Amendment C223 – Response to Direction 3(b)

In response to the Panel’s direction 3(b):

Confirmation by Council of the accuracy of shadow drawings and inputs to the extent possible (referencing concerns raised in some submissions).

Figure 1 Extract from Submissions 21A and 36A - Shadow Diagram

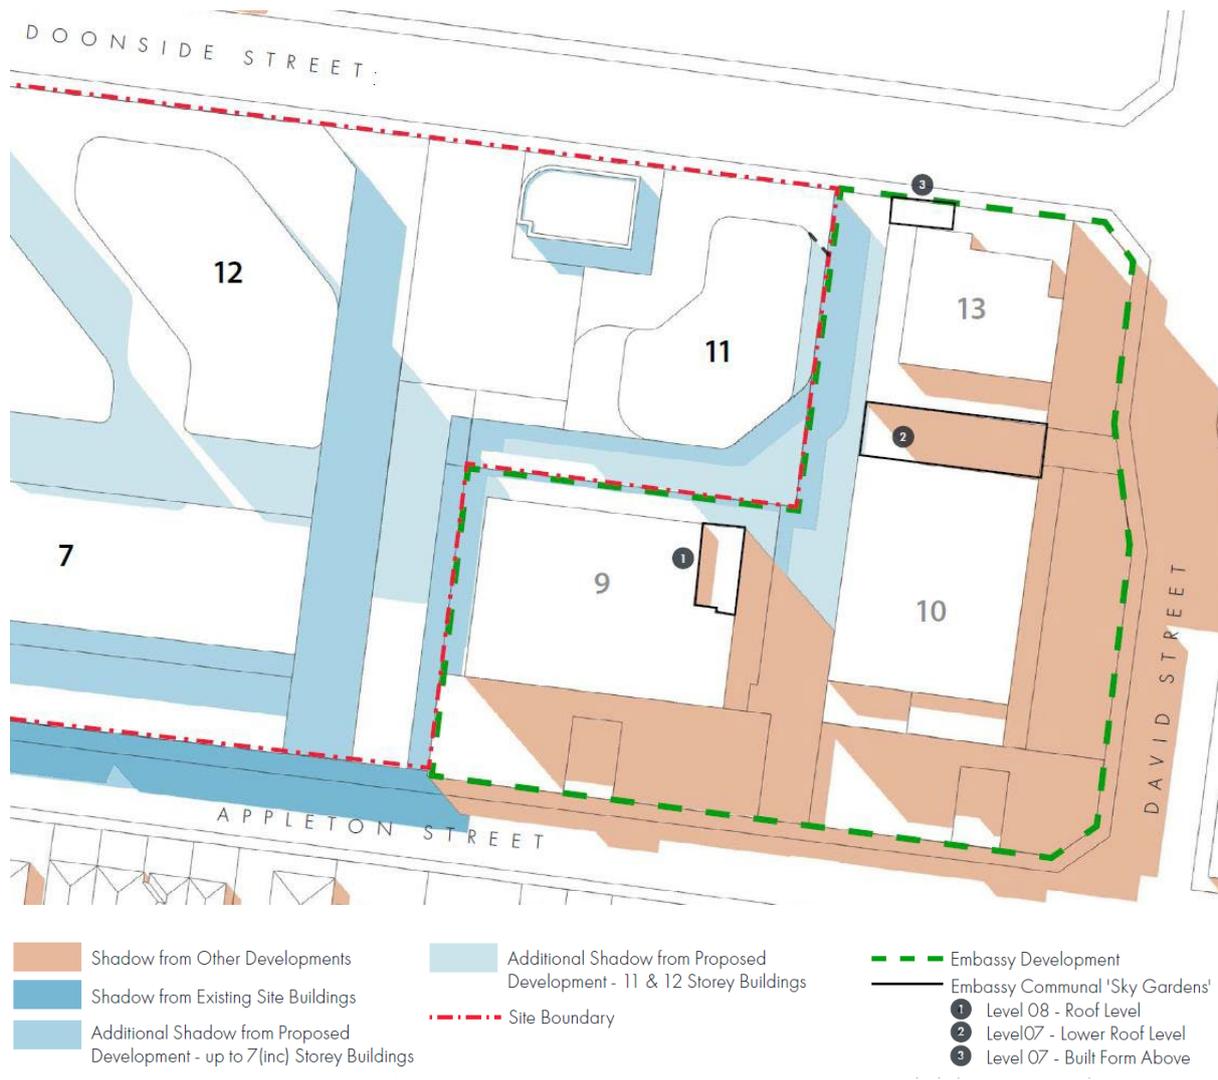
Several submissions (particularly submissions 21 and 36) raised concern regarding the accuracy of these diagrams, stating they misrepresented the outcome of a future development. An extract from submission 21A and 36A is provided below:

- The 3D image of the Shadow Studies provided are a misrepresentation of the proposed development for the following reasons:
- The Embassy development is NOT higher than the proposed 11-12 storey buildings.
- There are no overshadowing images for the ‘wall’ of 11-12 storey buildings, or how the height of these buildings might impact the completed Embassy development.
- This study has focused on Appleton Street and shadow studies for pedestrian laneways.
- The artist impression is irrelevant.
- The shadow study is created by an algorithm, not reality.
- Refer to photos we have provided with this objection that show ‘real’ buildings in the area.

In response to submissions Council officers sought additional shadow analysis from the proponent. The shadow analysis included a shadow study on the Embassy Building at the September equinox. The following shadow plan provided by TRACT Consulting, on behalf of the proponent, was included a plan in Council’s report dated 3 March 2020.

TRACT shadow plans included a note that:

Building footprint generally in accordance with Indicative Framework Plan.

September Equinox has been used, which is a recognised planning scheme test.

All building footprints indicative only.

Embassy building model reflects heights shown in endorsed plans (24/05/19).
